NEW PRODUCT BULLETIN # 355

PART NUMBER: 66855B
DESCRIPTION: Brake Drum
SIZE: 16.50 x 8.62
ESTIMATED WEIGHT: 122 lbs.

APPLICATION INFORMATION:
 R-SERIES DRIVE AXLE
 TN-SERIES TRAILER AXLE
 TP-SERIES TRAILER AXLE

66855B
(Without Oil Groove)

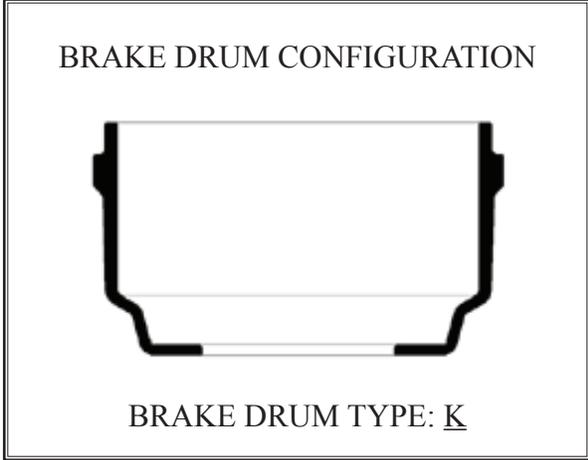
The 66855B brake drum is nearly identical to Webb's current 66854B, the only deviation being that the 66855B is machined without an oil groove in the wraparound (see figure below). Therefore, the 66855B brake drum will fit most applications where a 66854B brake drum is used, with the exception of a limited number of school bus applications where the machined oil groove is required. If a 66855 brake drum is required though balance isn't necessary, the equivalent unbalanced version of the 66855B brake drum is a 66854F.
